Facilitating Cleaner and Energy Efficient Phosphate Chemicals Industry in China (PhosChemEE) Project

Review CEO Endorsement and Make a recommendation

10722

PIF CEO Endorsement

ANNEX E: Project Budget Table

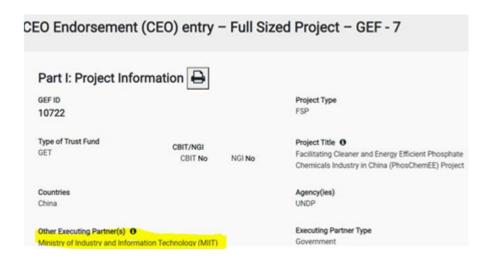
(vi) Local consultants for Monitoring and Evaluation / Terminal Evaluation are charged to PMC ? they must be charged to M&E ? please amend it.

Thanks for pointing this out. The other unnecessary texts in the description of the cost of the stated specific monitoring activities have been deleted. The explanations for the local consultant budgets have been re-stated as follows: USD 2,000/yr.*5= USD 10,000 (M&E) for Monitoring of social and environmental safeguard screening; USD 500/day * 40 = USD 20,000 for mid-term review (M&E); and USD 20,000 will be paid in Year 5 for Termination Evaluation. (M&E).
